UNITED STATES
NUCLEAR REGULATORY COMMISSION
WASHINGTON, D.C. 20555-0001

LICENSEES: Union Electric Company
Wolf Creek Nuclear Operating Corporation

FACILITIES: Callaway Plant, Unit 1
Wolf Creek Generating Station

SUBJECT: SUMMARY OF AUGUST 27, 2009, CATEGORY 1 MEETING WITH UNION ELECTRIC COMPANY AND WOLF CREEK NUCLEAR OPERATING CORPORATION – DISCUSSION OF REQUEST FOR ADDITIONAL INFORMATION FOR GENERIC LETTER 2004-02, "POTENTIAL IMPACT OF DEBRIS BLOCKAGE ON EMERGENCY RECIRCULATION DURING DESIGN BASIS ACCIDENTS AT PRESSURIZED-WATER REACTORS" (TAC NOS. MC4671 AND MC4731)

RAI Q 18.

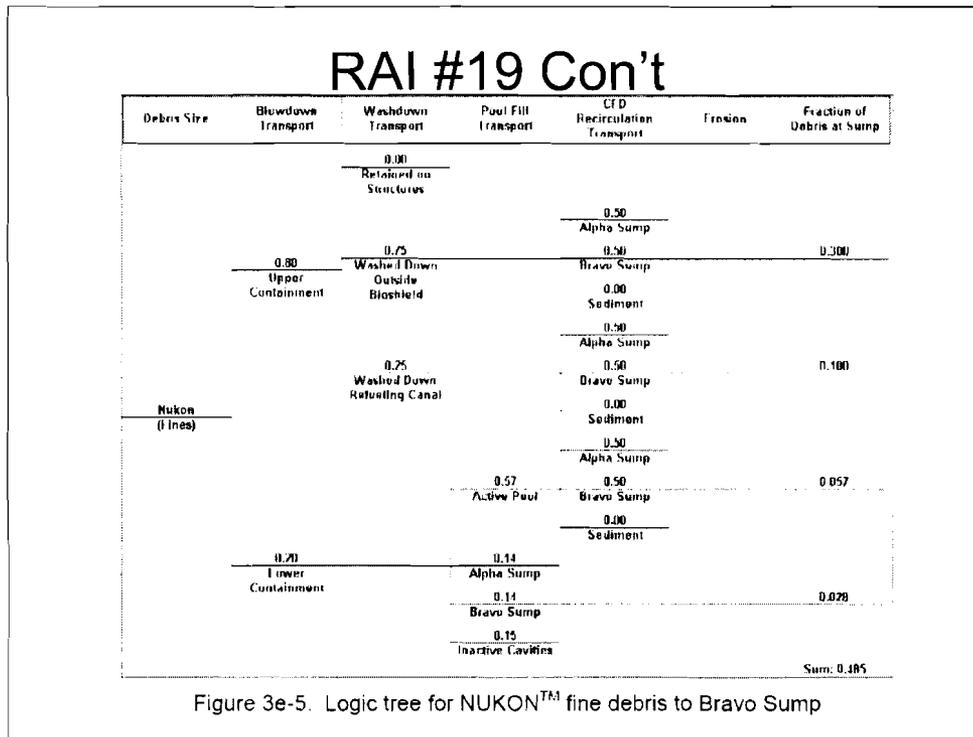
To the extent Foamless and Cerablanket are included in the limiting debris loading case, please provide an evaluation of their characteristics, such as characteristic size distribution (small pieces and fines, etc.) and density, and please provide justification for deviation from staff-approved evaluation methodologies.

- Neither Cerablanket nor Foamglas are debris types in the limiting debris load case for WCGS
 - Both had a SER maximum of 28.6D ZOI in the analysis
- Similar for AlphaMatD at Callaway
 - Had a SER maximum of 28.6D ZOI in the analysis and not part of the bounding debris case

RAI Q 38.

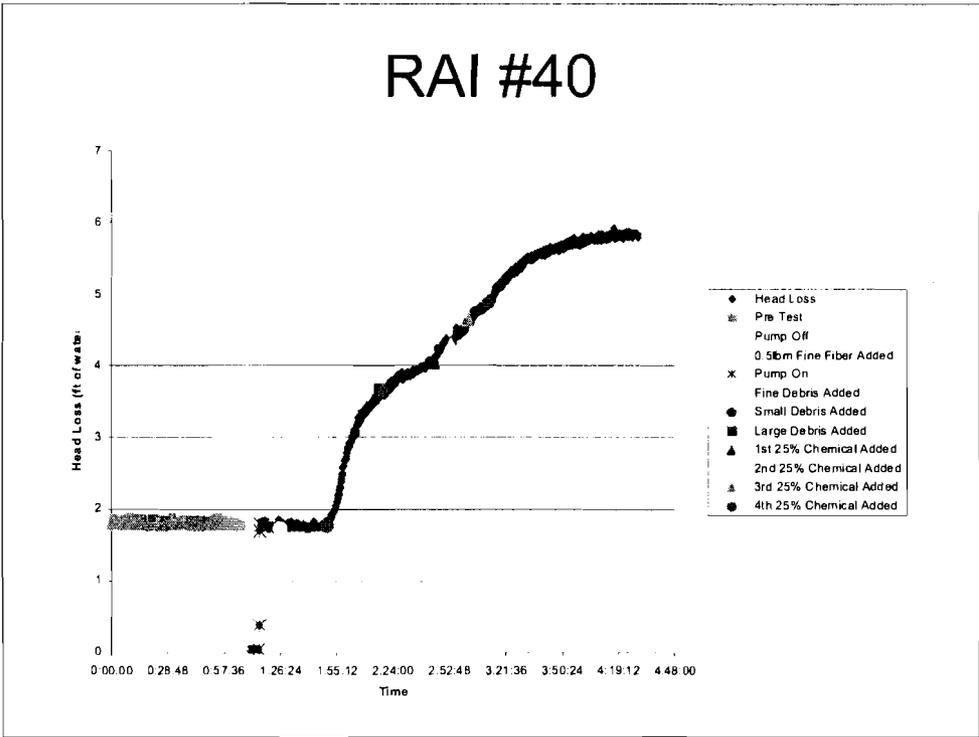
Please provide the clean strainer head loss (CSHL), including a breakdown of the portion attributable to the correlation (core tube) and the portion attributable to the standard calculation (plenum). The CSHL should be provided for the lowest temperature case for conservatism.
